DRG. NO. 7

UPIL CAMPUS AISHBAGH ROAD.
SHEET NO. 2
SITE PLAN

ARCHITECTURE & PLANNING UNIT II U.P. AVAS EVAM VIKAS PARISHAD LKO.

PART REVISED LAY-OUT PLAN FOR U.P.I.L. CAMPUS AISHBAGH YOJNA LUCKNOW.

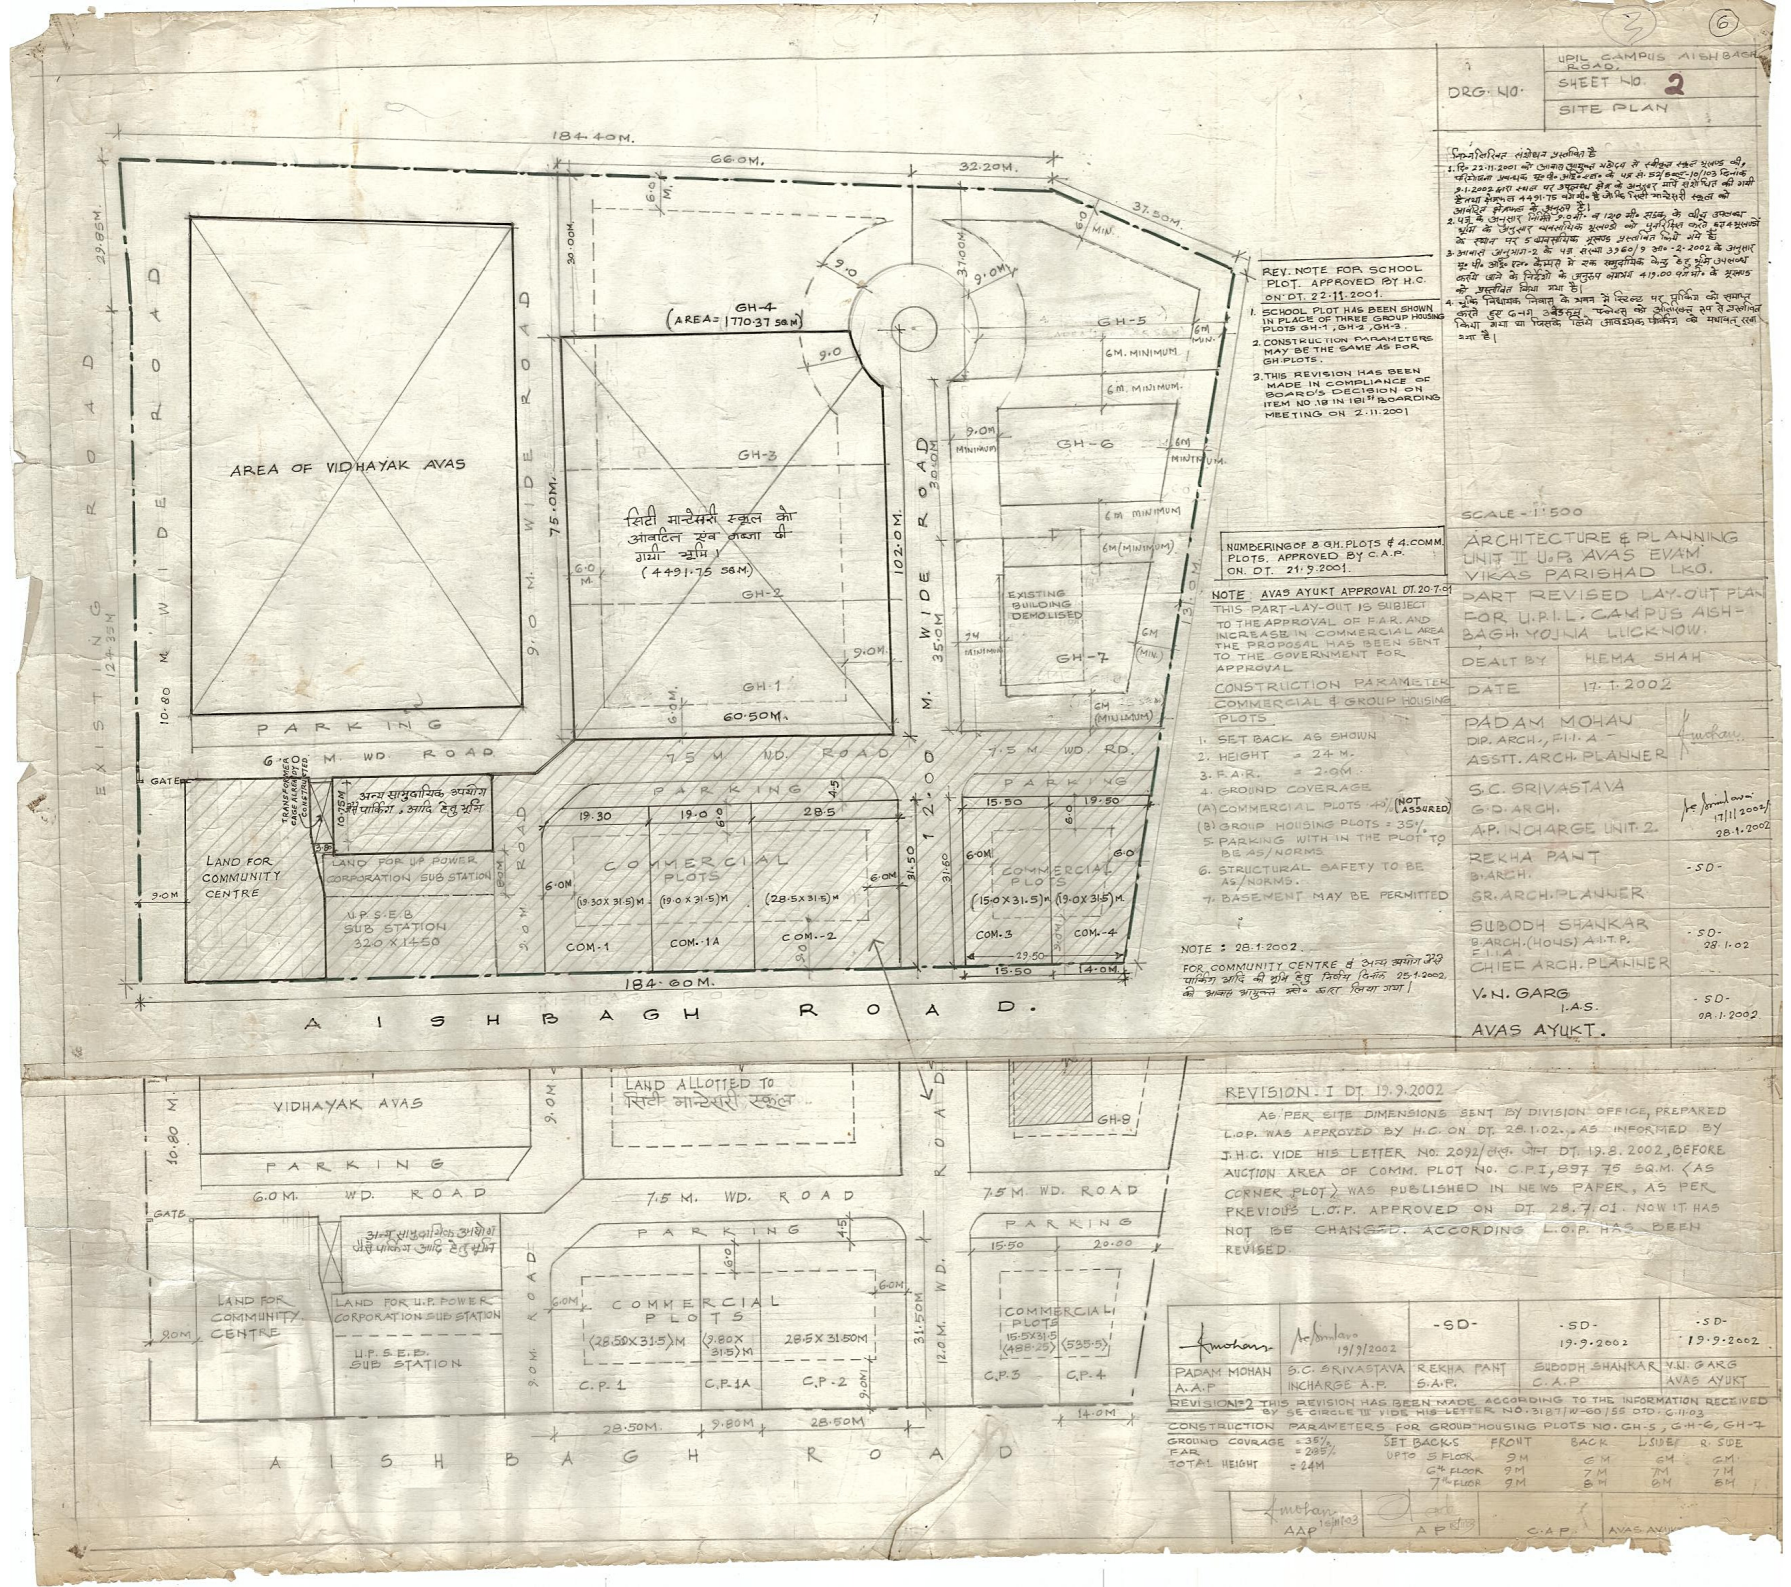
REV. NOTE FOR SCHOOL PLOT APPROVED BY H.C. ON DT. 22.11.2001.

1. SCHOOL PLOT HAS BEEN SHOWN IN PLACE OF THREE GROUP HOUSING PLOTS GH-1, GH-2, GH-3.
2. CONSTRUCTION PARAMETERS MAY BE THE SAME AS FOR GH PLOTS.
3. THIS REVISION HAS BEEN MADE IN COMPLIANCE OF BOARD'S DECISION ON ITEM NO. 18 IN 181st BOARDING MEETING ON 2.11.2001

NUMBERING OF 8 GH. PLOTS & 4 COMM. PLOTS, APPROVED BY C.A.P. ON. DT. 21.9.2001.

THIS PART-LAY-OUT IS SUBJECT TO THE APPROVAL OF F.A.R. AND INCREASE IN COMMERCIAL AREA THE PROPOSAL HAS BEEN SENT TO THE GOVERNMENT FOR APPROVAL.

1. दि. 22.11.2001 को उपाध्य तुलसी मंडल से संबंधित स्कूल भूखण्ड की, परियोजना अध्यक्ष यू.पी. आई.एल. के पत्र सं. 501/ब्लाट-10/103 दिनांक 9.1.2002 द्वारा स्थल पर उपलब्ध क्षेत्र के अनुसार मापी गयी भूमि 4491.75 वर्ग मी. है जो कि सिटी मान्टेसरी स्कूल को आवंटित क्षेत्रफल के अनुरूप है।
2. यू.पी. के अनुसार निर्णय 2.0.01 व 120 वीं साख के बीच उपलब्ध भूमि के अनुसार धनात्मक भूखण्डों को पुनर्परिभाषित करते हुए भूखण्डों के स्थान पर 5 आयतनीय भूखण्ड प्रस्तावित किये गये हैं।
3. आवास अनुभाग-2 के पत्र संख्या 3360/9 अ०-2-2002 के अनुसार यू.पी. आई.एल. कैम्पस में एक समुदायिक क्षेत्र हेतु भूमि उपलब्ध नहीं होने के निर्देशों के अनुरूप लगभग 419.00 वर्गमी. के भूखण्ड को प्रस्तावित किया गया है।
4. भूमि निर्धारण नियमों के अनुसार ग्रिल्ड पर भूमियों को समायोजित करते हुए G-H1, 2 व 3 के स्थान पर, फ्लैटस को अंतर्गत रूप से संशोधित किया गया था पार्सलों तक्षेत्र आवश्यक पार्किंग को समायोजित किया गया है।

AS PER SITE DIMENSIONS SENT BY DIVISION OFFICE, PREPARED L.O.P. WAS APPROVED BY H.C. ON DT. 28.1.02., AS INFORMED BY J.H.C. VIDE HIS LETTER No. 2092/ले.प्रो. DT. 19.8.2002, BEFORE AUCTION AREA OF COMM. PLOT NO. C.P.1, 897.75 SQ.M. (AS CORNER PLOT) WAS PUBLISHED IN NEWS PAPER, AS PER PREVIOUS L.O.P. APPROVED ON DT. 28.7.01. NOW IT HAS NOT BE CHANGED. ACCORDING L.O.P. HAS BEEN REVISED.

REVISION-2 THIS REVISION HAS BEEN MADE ACCORDING TO THE INFORMATION RECEIVED BY SE-CIRCLE II VIDE HIS LETTER NO. 3187/W-60/58 DTD. 6.11.03

CONSTRUCTION PARAMETERS FOR GROUP HOUSING PLOTS NO. GH-5, GH-6, GH-7

GROUND COVRAGE = 35%
FAR = 285%
TOTAL HEIGHT = 24M

SET BACKS	FRONT	BACK	L SIDE	R. SIDE
UPTO 5 FLOOR	9M	6M	6M	6M
6th FLOOR	9M	7M	7M	7M
7th FLOOR	9M	8M	8M	8M
